This email thread relates to a comment that will be discussed in San Francisco during Qbf sponsor ballot comment resolution.

**From:** tonyjeffree@googlemail.com [mailto:tonyjeffree@googlemail.com] **On Behalf Of** Tony Jeffree  
**Sent:** Wednesday, May 25, 2011 5:35 AM  
**To:** Stephen Haddock  
**Cc:** Robert sultan; Panagiotis Saltsidis; ao.ting@zte.com.cn  
**Subject:** Re: RE: One issue about 802.1Qbf

**Figure 20-8—MEP Traffic Field Mismatch state machine**

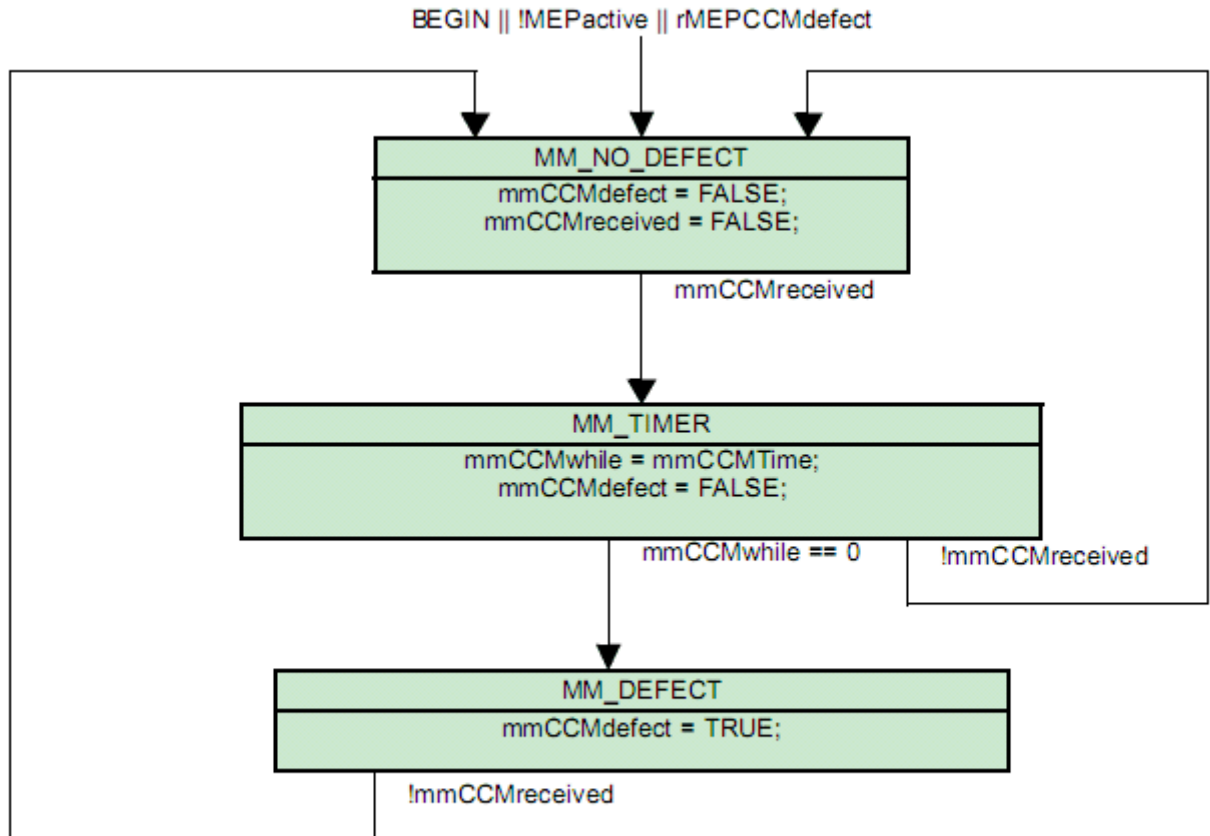
And in 802.1Qbf, we re-use the mismatch mistake state machine Figure 20-8. In the figure, there is a variable `mmCCMdefect` which is set to TRUE when the `mmCCMwhile=0` and `mmCCMreceived=1`. So in this figure, we know that the `mmCCMdefect` is the variable in infrastructure segment MEP.

But we only define the `mmCCMdefect` in 802.1Qay:

### 20.25.2 `mmCCMdefect`

A Boolean flag set and cleared by the MEP Mismatch state machines to indicate that one or more CCMs with Traffic fields not matching the `presentTraffic` (20.9.8) has been received, over a period that is 3.5 times the configured CCM transmission rate.

Here `presentTraffic` is variable in PBB-TE MEP.

So I think the issue is in 802.1Qbf, we hope the `mmCCMdefect` is applicable to infrastructure segment MEP. But we missed defining `mmCCMdefect` in 802.1Qbf.

My suggestion is to add the sub-clause 20.25.2 in 802.1Qbf as following:

### 20.25.2 **mmCCMdefect**

A Boolean flag set and cleared by the **PBB-TE MEP Mismatch** state machines to indicate that one or more CCMs with Traffic fields not matching the presentTraffic (20.9.8) has been received, or by **infrastructure segment MEP mismatch state machines** to indicate that one or more CCMs with Traffic fields not matching ISpresentTraffic (20.9.10) has been received, over a period that is 3.5 times the configured CCM transmission rate.
